# DART SERVICE INSTRUCTION

TO AMEND INSTALLATION INSTRUCTIONS IIN-D407-797 REV. C AND INSTRUCTIONS  
FOR CONTINUED AIRWORTHINESS ICA-D407-797 REV. 3 OR LATER APPROVED  
REVISION

REF. TCCA STC: SH11-1  
REF. FAA STC: SR02996NY  
REF. EASA STC: 10035429

The purpose of this DSI is to provide the instructions to replace the D4029-041 Webbing on the D3915-041 Light Lid Assembly used in the DXXX-797-013/-014/-023/-024/-101 kits.

**Figure 1 - D3915-041 Light Lid Webbing Replacement**

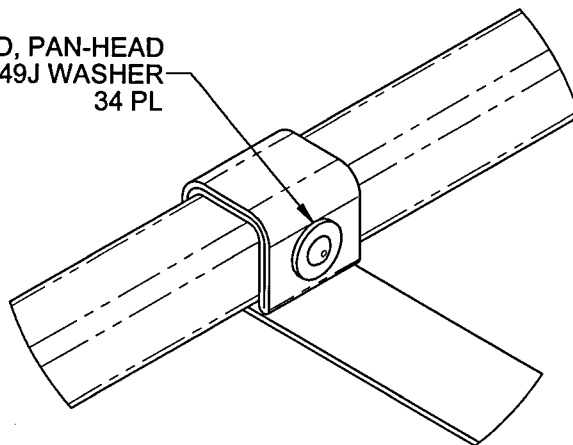
1. Remove the D3915-041 Light Lid Assembly per Section 25.6 of ICA-D407-797 as applicable.
2. Remove the MS20600AD4W4 Rivets and the NAS1149DN949J Washers per Figure 1 and remove the D4029-041 Webbing.

- (D) Use 1x MS20600AD5W2 Rivet to plug each hole.
4. Install the replacement D4029-041 Webbing using MS20600AD4W4 Rivets and NAS1149DN949J Washers per Figure 1.

MS20600AD4W4 RIVET, BLIND, PAN-HEAD  
NAS1149DN949J WASHER  
34 PL
